Re: St. Lucie Units 1 and 2
Docket Nos. 50-335 and 50-389
Fourth Ten-Year Interval In-Service-Test Program Submittal
RAI Reply to Relief Request PR-04 (TAC No. MD7748)

RAI Reply for Pump Relief Request – PR-04
Low Pressure Safety Injection Pump Group Classification

Attachment 3, Unit 1 LPSI Pump Spectral Vibration Data 1995 to 2002. (6 pages)

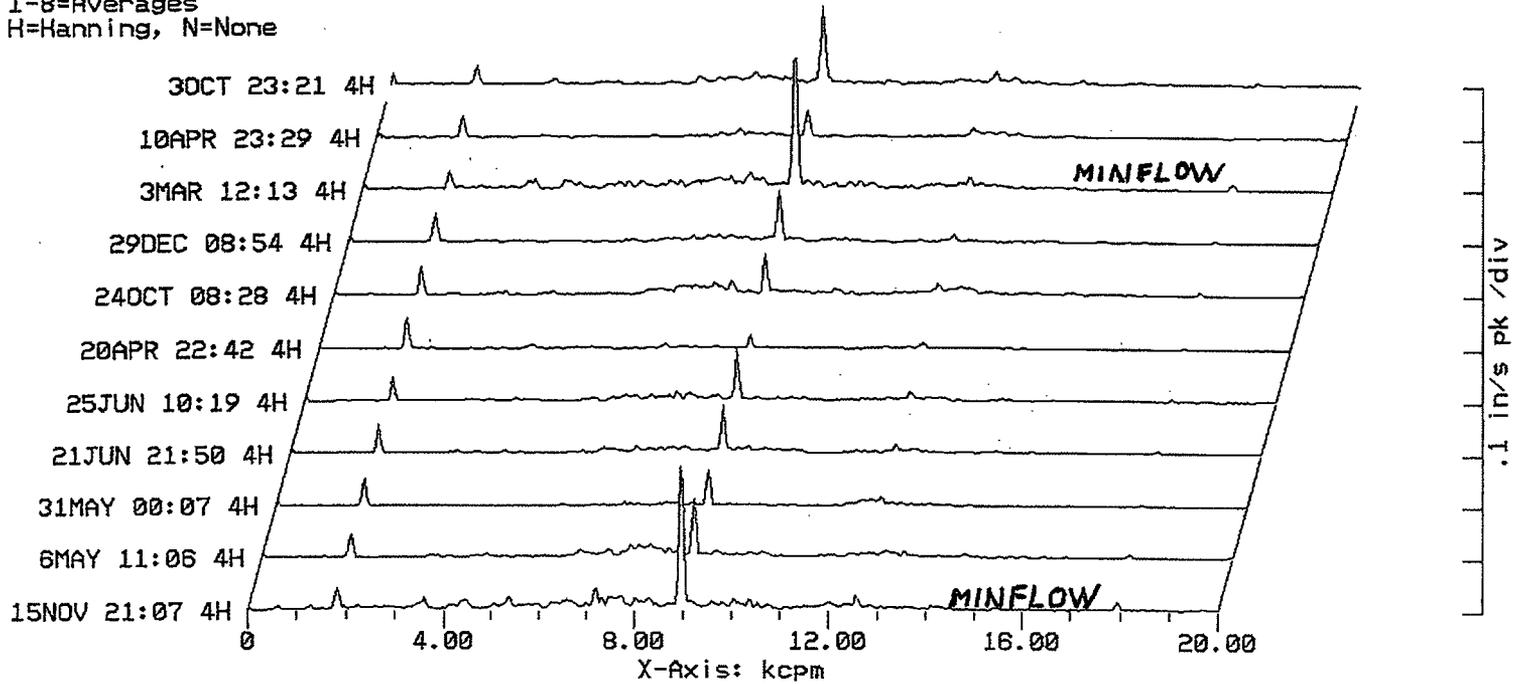
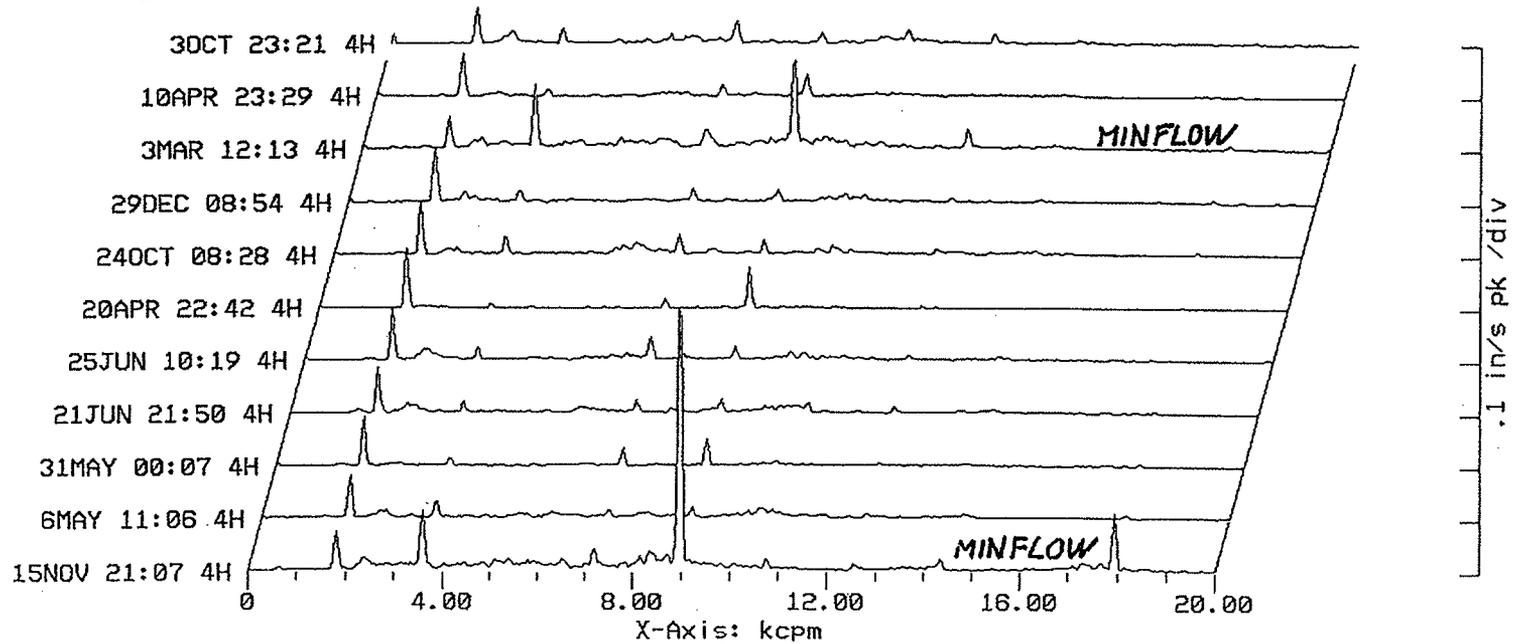
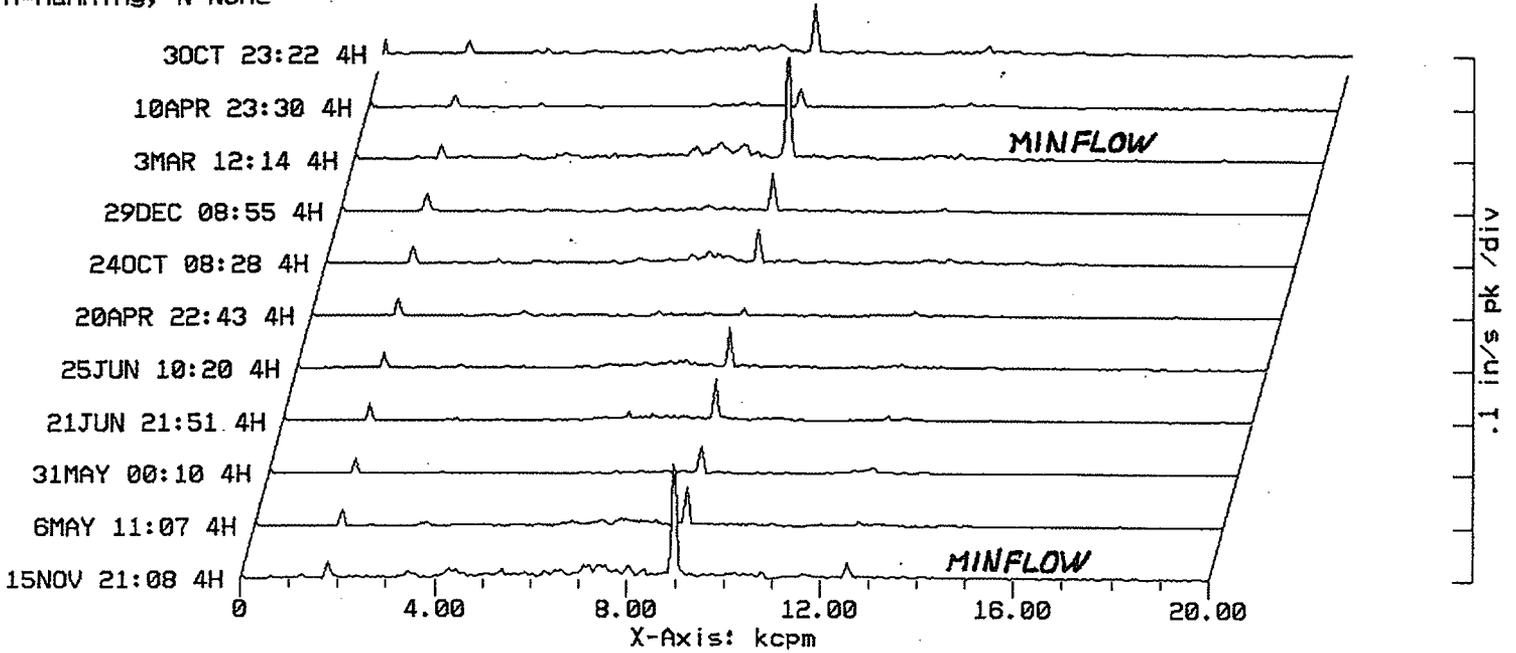
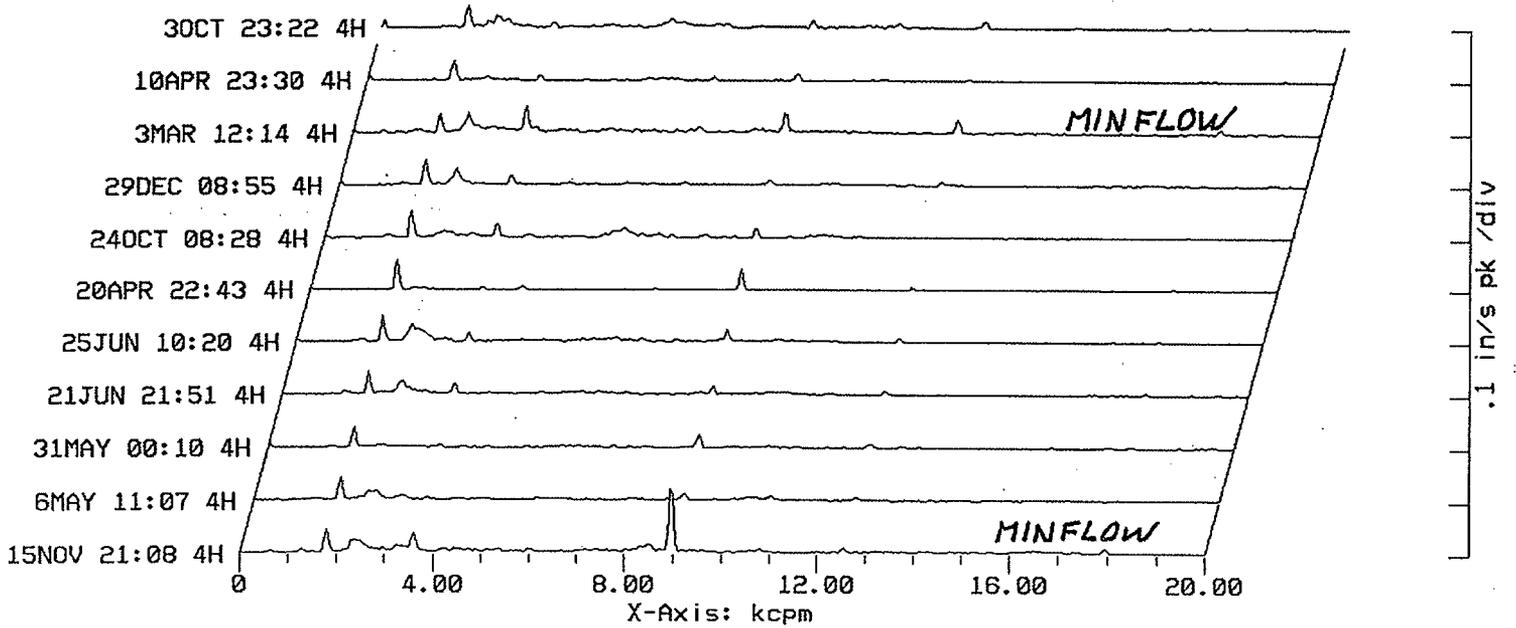
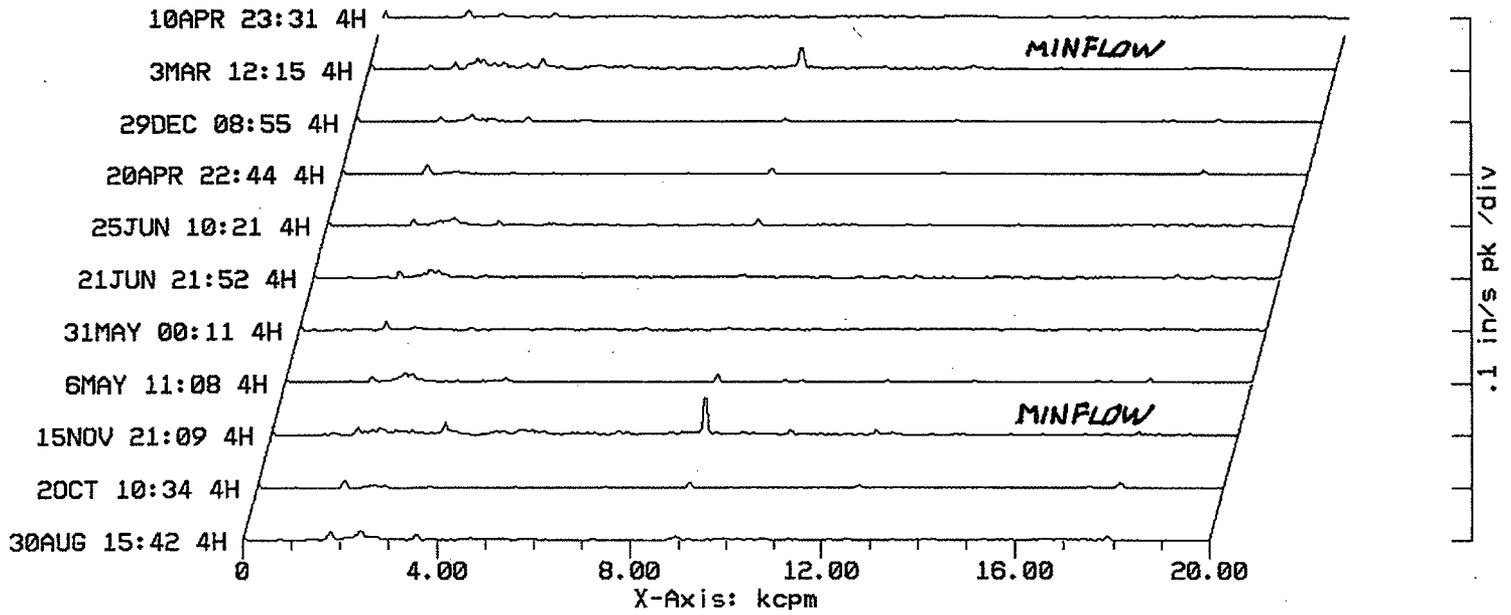
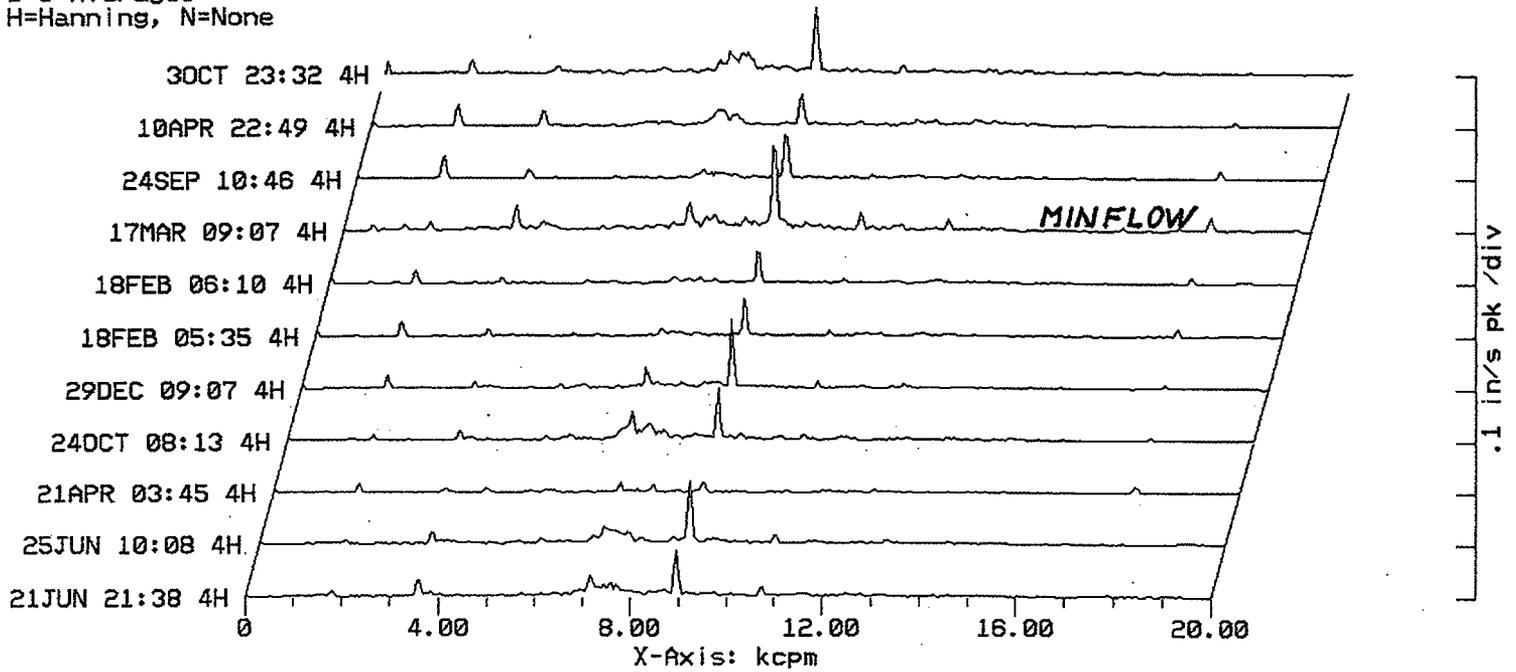
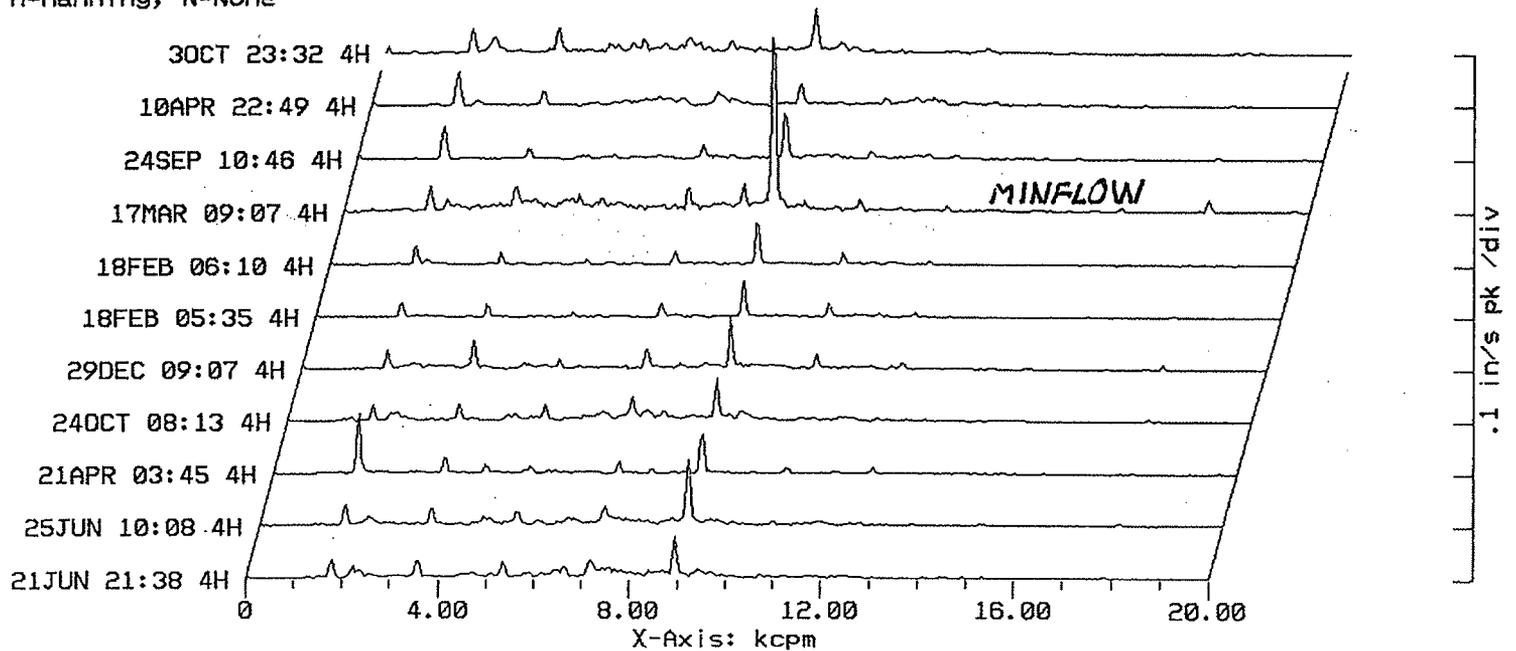
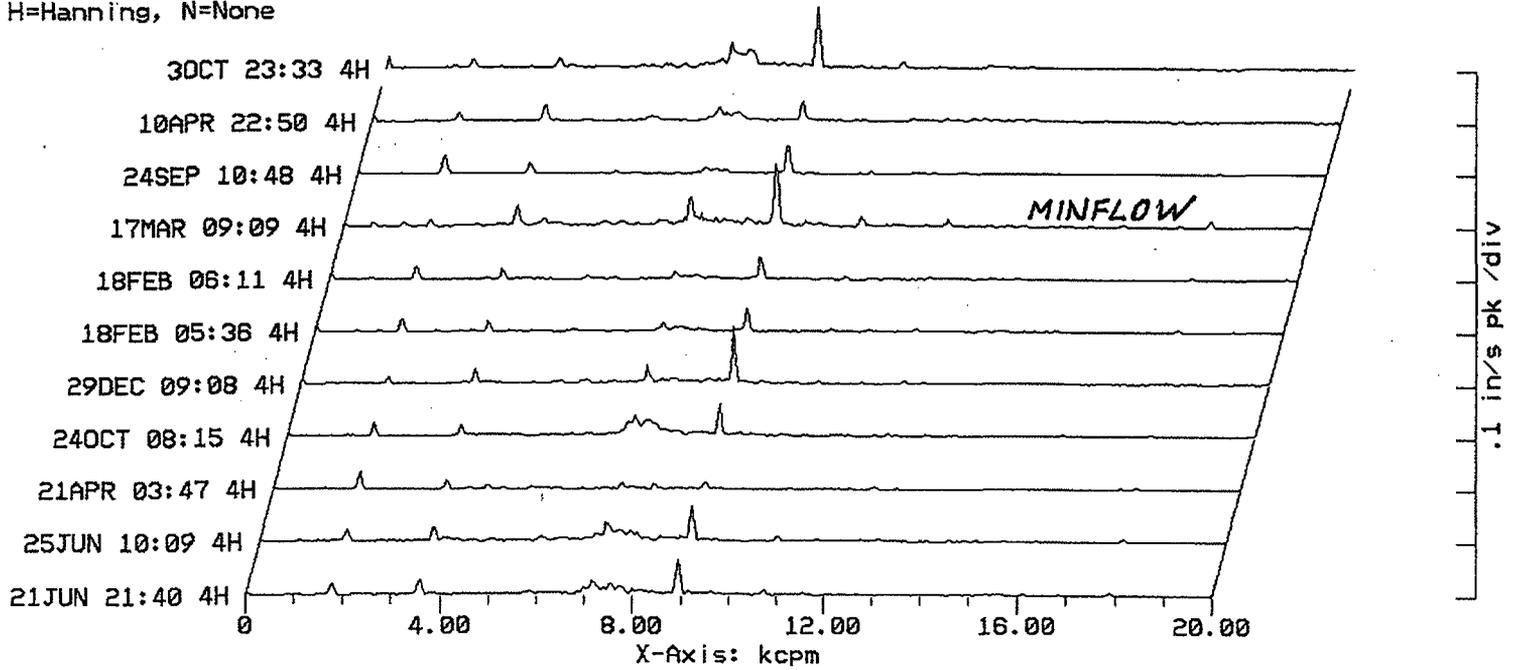
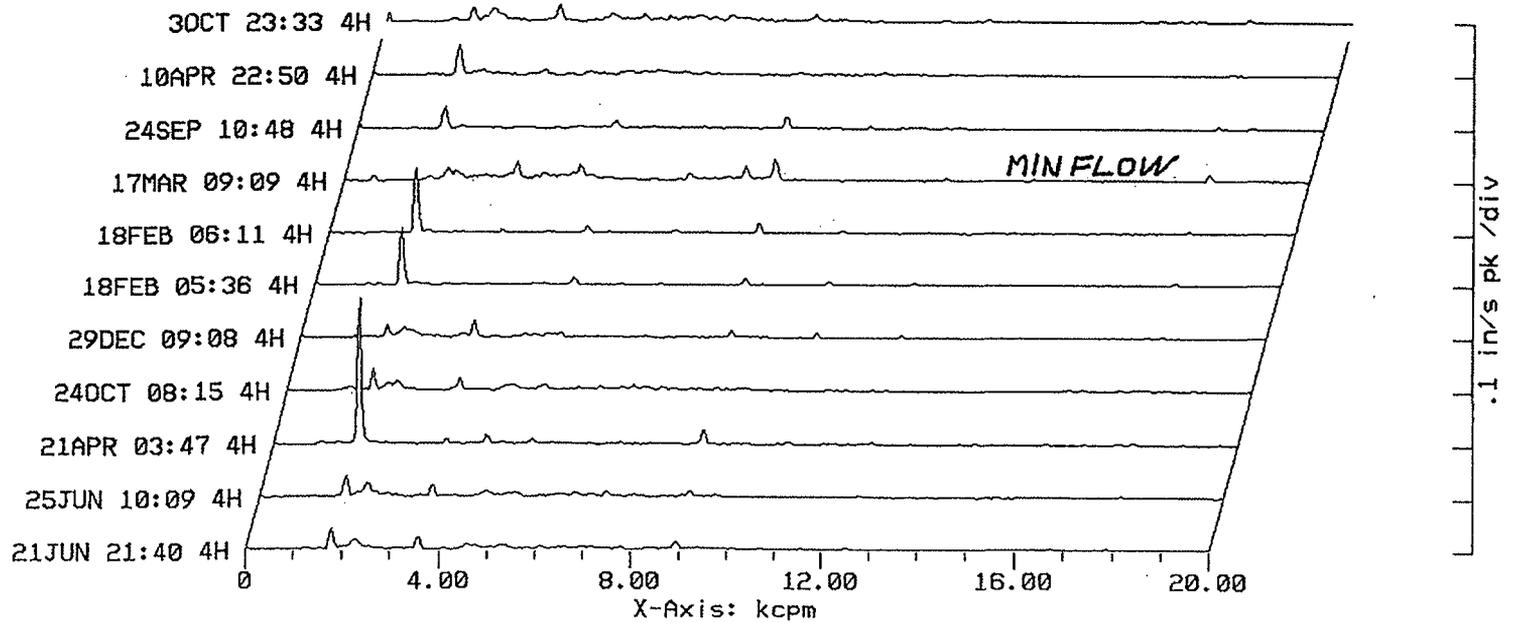
The following information is provided to supplement Relief Request Number “PR-04” submitted by Florida Power and Light Company under FPL Letter L-2007-144. This information is provided based on a telephone conversation between the NRC and FPL on July 2, 2008. Specifically, the NRC requested that the licensee provide basis and details for accepting the higher vibration values of 0.325 in/sec to 0.5 in/sec seen while testing the Unit 1 low pressure safety injection (LPSI) pumps under mini-recirculation flow conditions as described in previous PR-12 during the 3rd 10-year interval IST program. Additionally, the NRC requested that St. Lucie describe additional non-Code monitoring and spectral analysis activities performed on the LPSI pumps under design flow conditions during outages.

The Unit 1 LPSI pumps are included in the plant predictive maintenance (PDM) monitoring program, therefore, many years of spectral analysis and trend data from PDM test results are available for review (Attachments 3 and 4). PDM usually collects data when the pumps run at needed shutdown cooling (SDC) flows, but occasionally data is collected at the Section XI full flow and minimum flow tests. From the spectral patterns it can be seen that, at minimum flow conditions,

both pumps generate increased vibration levels. At low flow, vibration velocity levels at five running speed frequencies (5X), the vane passing frequency, are significantly increased due to elevated vane pass vibration since the water's velocity vector is not striking the volute tongue at the optimal angle. The increased vibration at the 2X frequency is a result of an abnormal pressure distribution in the volute that acts to asymmetrically load the impeller. Also contributing to the overall vibration increase is hydraulic broadband "spectral floor" energy generated by shock energy due to increased turbulence and internal recirculation flow.

As can be seen in Attachments 3 and 4 near BEP, the hydraulic vibration patterns are normal and expected. At lower flows there is increased vane pass (5X) and floor energy. As the flows return to near BEP the vibration patterns and levels return to normal. Therefore, though overall vibration can dramatically increase at low flow conditions, reaching 0.45-0.50 in/sec on these pumps, there is little sign that the pump condition would be degrading.

Bearing defect frequencies are generated from anti-friction (ball) bearings when the bearing surfaces are degraded. These frequencies are not present until a defect forms in the bearing itself. Depending on the specific location of the defect, the rolling elements will strike the defect at a certain frequency driven by the bearing geometry and the rotating speed. The bearing defect frequencies (inner race, outer race, ball, and cage) are normally calculated and compared to any spectral frequencies that appear. These frequencies are typically obvious when displayed in the spectral trend format, so changes are quickly apparent. As can be seen in Attachments 3 and 4 there are no bearing defect frequencies that have appeared in the spectrums.
